30-045-05547 CENTRAL BISTI UNIT #008

DJR Operating, LLC requests permission to Plug & Abandon the subject well according to the attached Procedure, Current & Proposed Wellbore Diagram, & Reclamation Plan.

Plug and Abandonment Procedure

Attachment to notice of
Intention to Abandon: EC#516061

Proposed PXA Wellbore Diagram

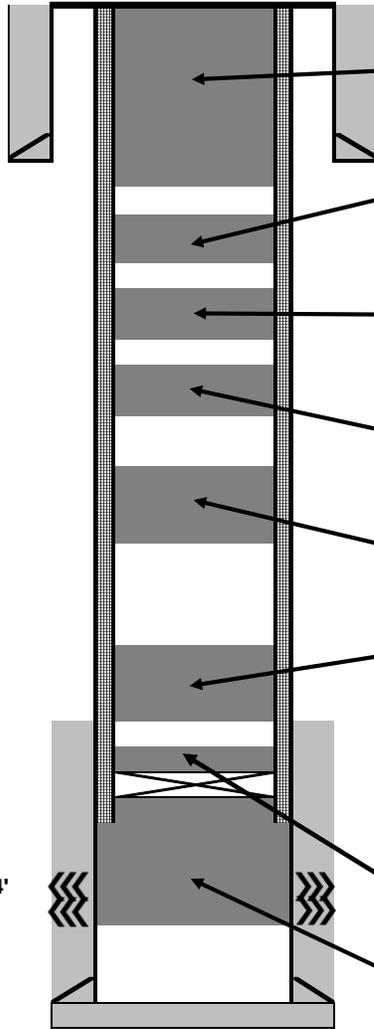
- Extend the top of Plug #7 to 350'. OCD Ojo Alamo pick @ 400'.

1. Plugging operations authorized are subject to the attached "General Requirements for Permanent Abandonment of Wells on Federal and Indian Lease"
2. Farmington Office is to be notified at least 24 hours before the plugging operations commence (505) 564-7750
3. Submit a copy of the updated procedure reflecting geologic report and all COAs to the following email addresses before operations commence: jkillins@blm.gov , jhoffman@blm.gov and Brandon.Powell@state.nm.us
4. Submit electronic copy of the CBLs for verification to the following addresses: jkillins@blm.gov , jhoffman@blm.gov and Brandon.Powell@state.nm.us . Based on CBL results inside/outside plugs and volumes will be adjusted accordingly. Required plug coverage is based on attached BLM geologic report.
5. BLM picks top of Cliffhouse SS at 1843'. Expand plug 4 to cover 1793' – 1893'.
